Staff Report for Administrative Approval Hillside Review – Notice of Conditional Approval

Weber County Planning Division

Application Request: Consideration and action on a request to approve a Hillside Review for Lots 9R, 10R, 11R, 12R, 14R and 15R in the Summit Eden Ridge Nests PRUD, Amendment 1 located in Cache County, Utah

File Number: HSR 2016-17

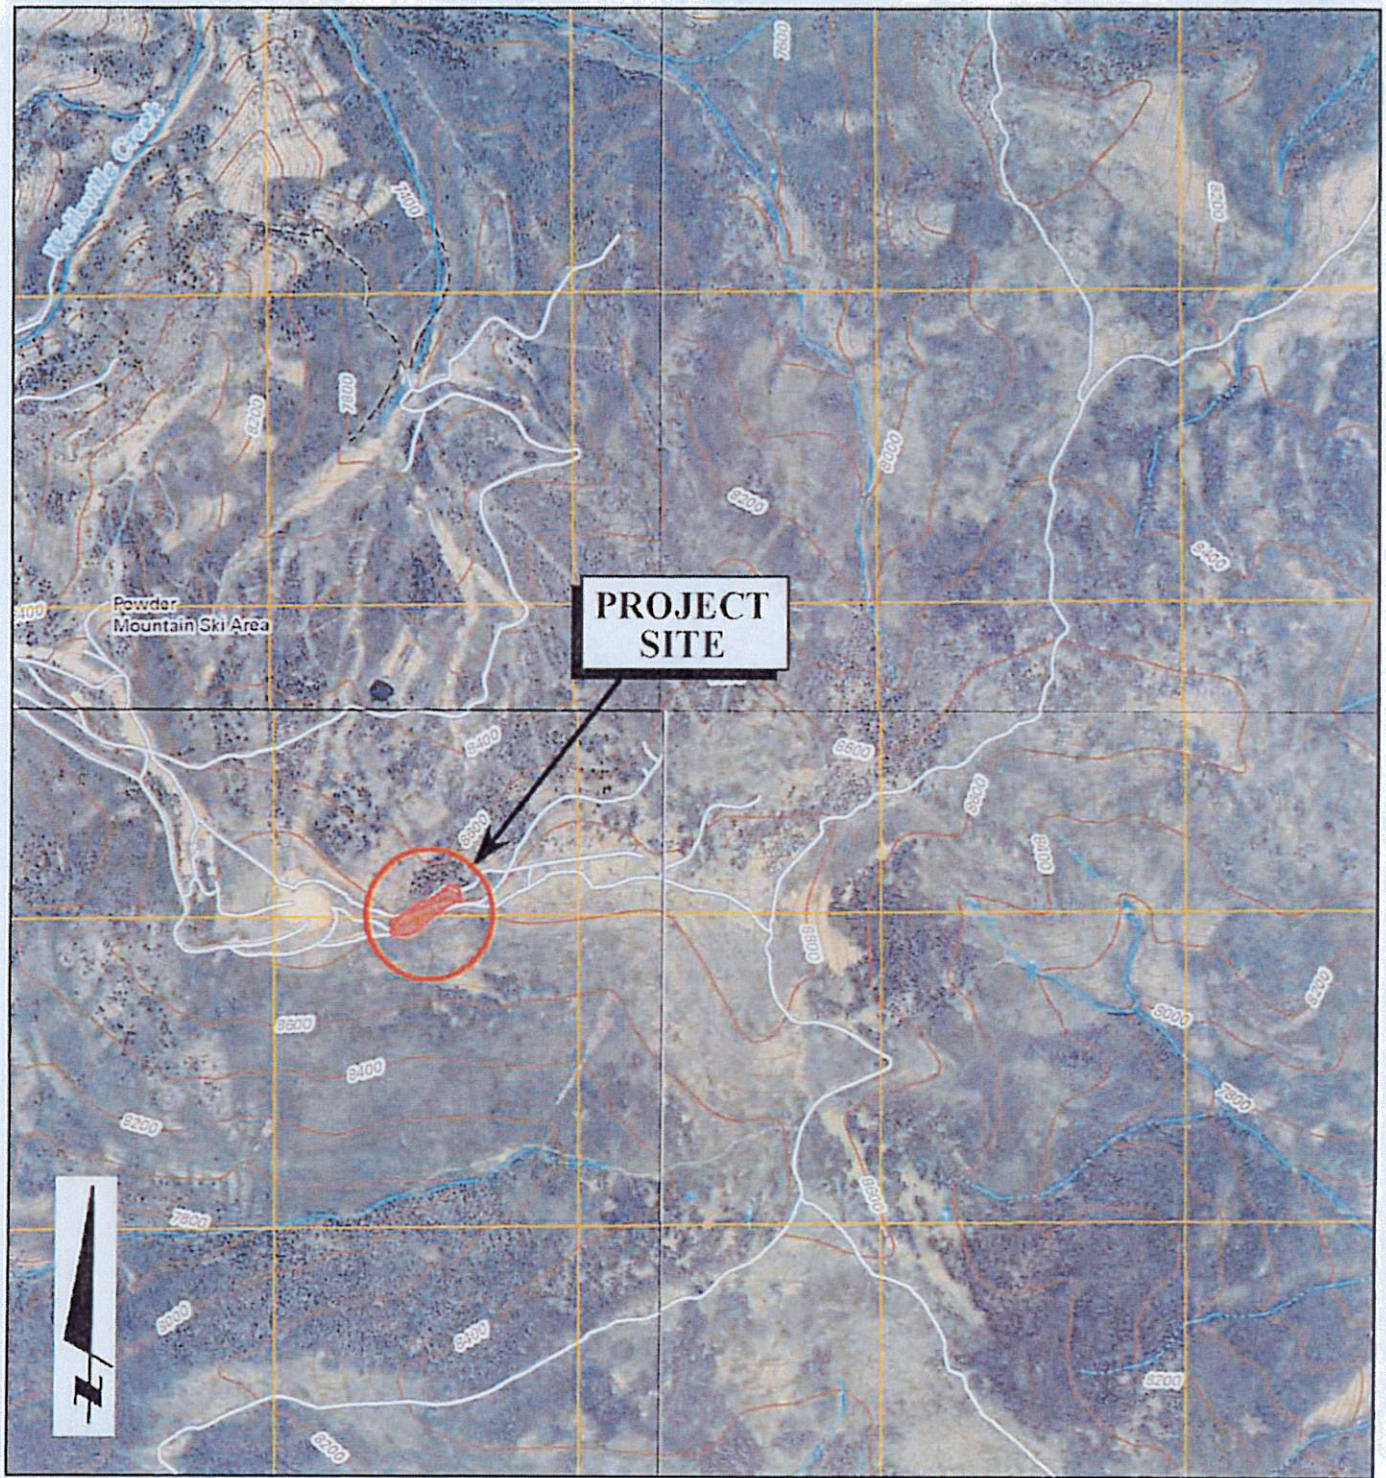
"Figure A-2, Geotechnical Map, of the September 16, 2014 IGES report depicts "...the relative locations of the various geologic units..." described in the September 16, 2014, IGES report. SA recommends Weber County request IGES:

A geologic investigation of Lot 13 and the immediate area surrounding the Ridge Nests subdivision was conducted by an IGES engineering geologist between August 26 and 27, 2015. Plate 1 (*Geologic Map*) is an updated, expanded version of the original Figure A-2, *Geotechnical Map*, from the IGES geotechnical report. The geologic mapping has been extended to several hundred feet in all directions from the original map, and minor modifications to the original geologic contacts have been made based upon the findings of the investigation. Additionally, bedding and jointing attitudes, and the approximate locations and orientations of identified faults are presented on the map. Two geologic cross-sections providing a representative picture of the subsurface of the property are illustrated on Figure 1. A brief description of the findings of the geologic investigation follows.

FIGURE 1

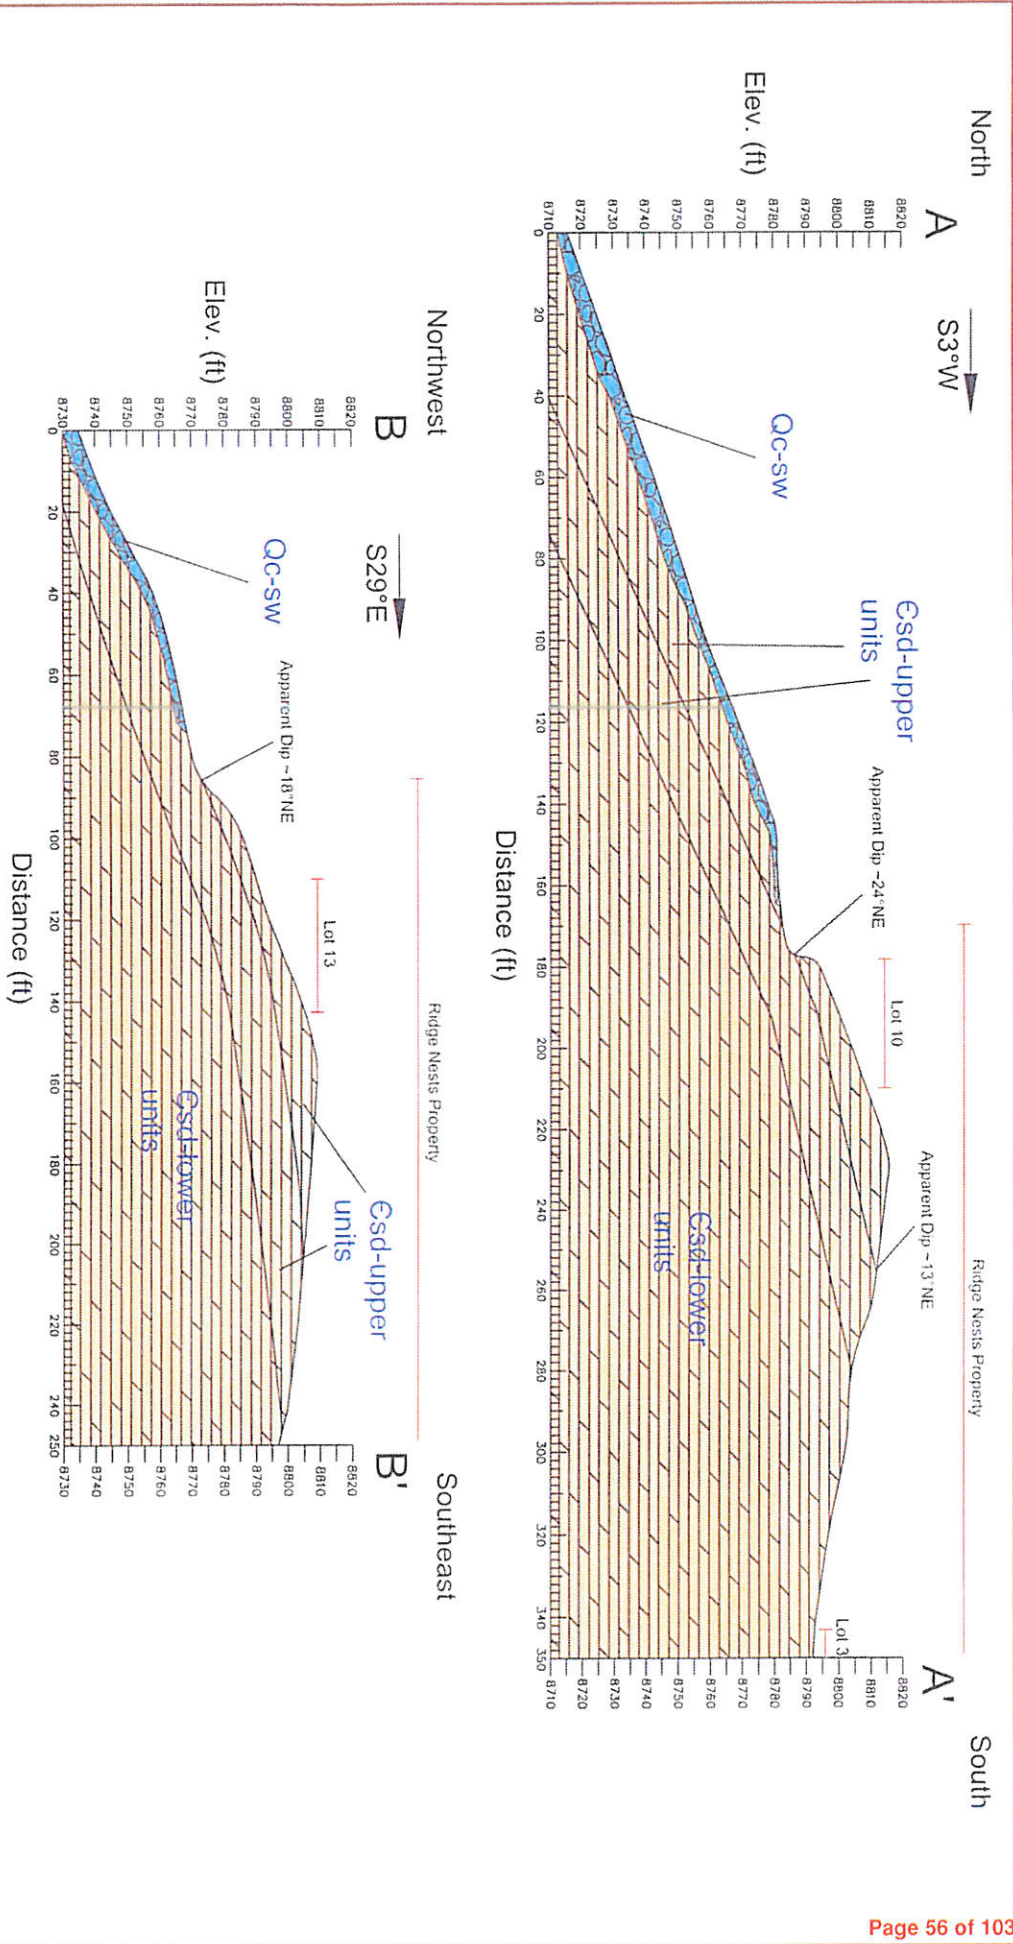
Comment No. 1

The global stability of the slope was modeled using gSTABL7 slope stability software. Bishop's Method and Janbu's Simplified method was used to model the slope, as appropriate. For our analysis, we have assessed two representative sections, Section A-A' and Section B-B', illustrated on Plate 1 (*Geologic Map*) and the *Geologic Cross-Sections*, Figure 1, attached. Calculations for stability were developed by searching for the minimum factor-of-safety for both a circular-type failure and a block-type (translational) failure. For the circular analysis model, arcuate failure surfaces and homogenous earth materials were assumed. For the block analysis, anisotropic strength parameters in the bedrock was assumed, based on the apparent dip of bedding. A minimum static factor-of-safety of 1.5 and seismic factor-of-safety of 1.0 (global stability) was considered acceptable for this project considering the available information and design assumptions.

Figure 10. Dolomite lithology

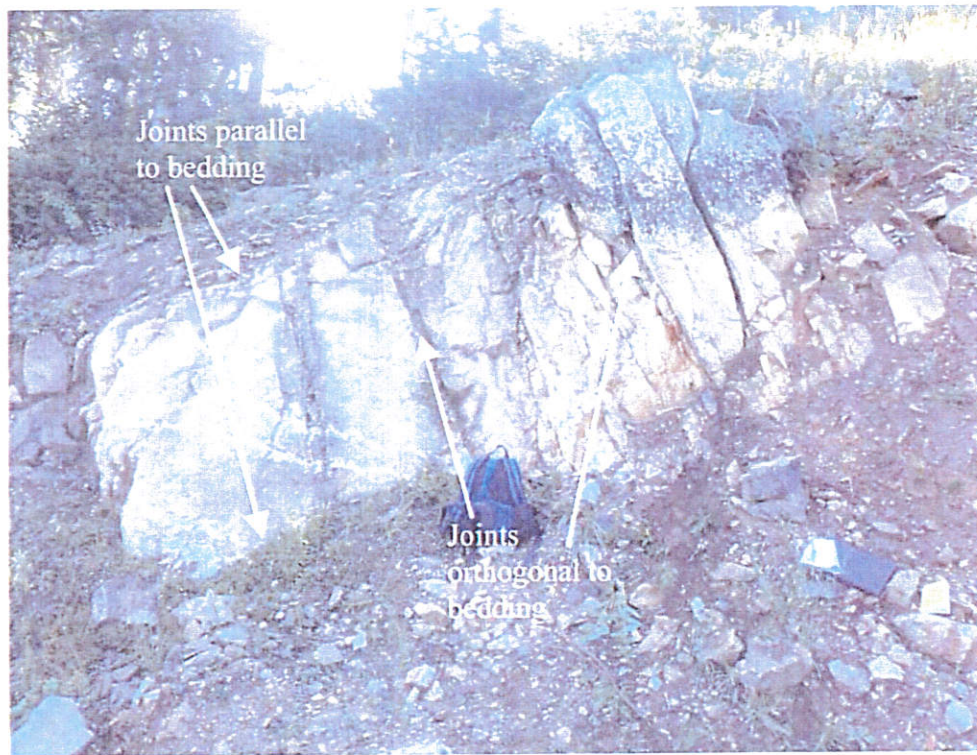
"The September 23, 2015, IGES response letter did not describe the properties of the bedding and/or jointing for incorporation into the slope stability analyses, e.g., properties such as, strike and dip, degree of fracturing (generally controlled by the number of joints in a given direction), persistence of jointing, spacing of jointing, roughness of joint surface, open and/or closed joints, joint coatings and infillings, etc.

Should the Weber County Consulting Geotechnical Engineer consider the properties of bedding, joints, and/or fractures pertinent in regards to slope stability analyses presented in the September 23, 2015 IGES response letter, SA recommends Weber County request documentation of the bedding, joint, and/or fracture properties, and incorporation of the geologic data in the slope stability analyses."

IGES did describe the strike and dip of the bedding and jointing in the September 23, 2015 response letter; IGES noted bedding near the subject site was oriented (strike) about N24°W and dip (inclination from the horizontal) at 25°NE. The bedrock was found to have blocky jointing, with the two major sets being orthogonal to one another. One joint set was parallel to the bedding, and the other was perpendicular to the bedding, dipping steeply to the southwest. The joint set parallel to the bedding has the same strike and dip orientation as the bedding, while the other major joint set perpendicular to the first has a strike of approximately N24°W and a dip of approximately 65°SW.

In response to the comment, the following additional details are provided: bedrock was found to be largely moderately fractured (distance between fractures ~0.5-1.0 feet) to little fractured (distance between fractures ~1.0-4.0 feet), with localized areas of intense fracturing (distance between fractures ~0.05-0.1 feet). Joint spacing was largely found to be a product of the lithology. The finer-grained dolomite lithologies were more thinly bedded, and therefore had a smaller distance (approximately 1 to 4 inches) between bedding plane joints. These lithologies also tended to fracture into rectangular blocks generally between 4 and 18 inches in length and width, and contained both bedding-confined and through-going fractures (Photo 1). Coarser-grained dolomite lithologies were more thickly bedded to massive, with bedding plane joints separated by between 6 inches to as much as several feet. These lithologies tended to fracture into rectangular blocks with highly variable dimensions, ranging in width and length from between a couple inches to several feet, though larger blocks (with dimensions of several feet x several feet x several feet) were most common (Photo 2). Most fracturing associated with the coarser-grained dolomite lithologies consisted of large through-going fractures.
